UNITED STATES PATENT AND TRADEMARK OFFICE

APPLICATION NO.	FILING DATE	FIRST NAMED INVENTOR	ATTORNEY DOCKET NO.	CONFIRMATION NO.
10/617,026	07/11/2003	Seung-Woo Lee	6192.0302.US	2713

Office Action Summary	Application No.	Applicant(s)	
	10/617,026	LEE ET AL.	
	Examiner	Art Unit	
	Seokyun Moon	2629

DETAILED ACTION

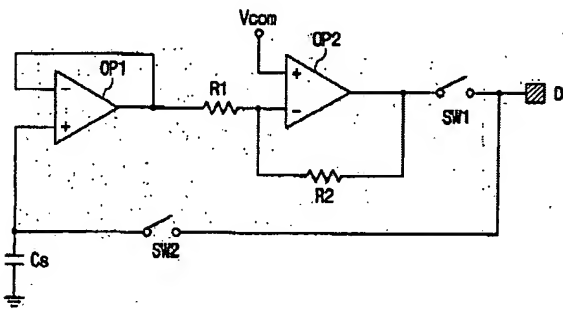
As to **claim 4**, Kim modified by Lien teaches the slave driver comprising:

a storage (Lien: "*full frame buffer*") [Lien: fig. 3] for storing the data voltages applied to the data line in the second period; and

an inverter (Lien: "*inverter 6*") [Lien: fig. 3] for inverting the polarity of the data voltages stored in the storage [Lien: fig. 2f], the storage and the inverter alternately connected to the data line (Lien: "*analog toggle 4*" alternately connects the storage and the inverter to the data lines) [Lien: col. 5 lines 40-49].

Drawing 1

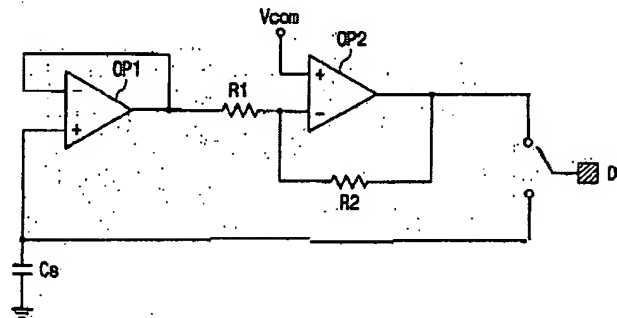
As to **claim 8**, Kim modified by Lien does not expressly teach the switch unit to comprise a first switch and a second switch.

However, since the Applicants have failed to disclose that including two switches in the switch unit provides an advantage, is used for particular purpose, or solves a state problem, it is an obvious matter of design choice to include two switches in the switching unit.

Therefore, it would have been obvious to one of ordinary skill in the art at the time of the invention to use a toggle switch for the switching operation of the driver, since a toggle switch would perform equally well at selectively connecting inputs from the storage and the inverter to the data line. Drawing 1 is provided below to illustrate an alternative design/structure for the switching unit.
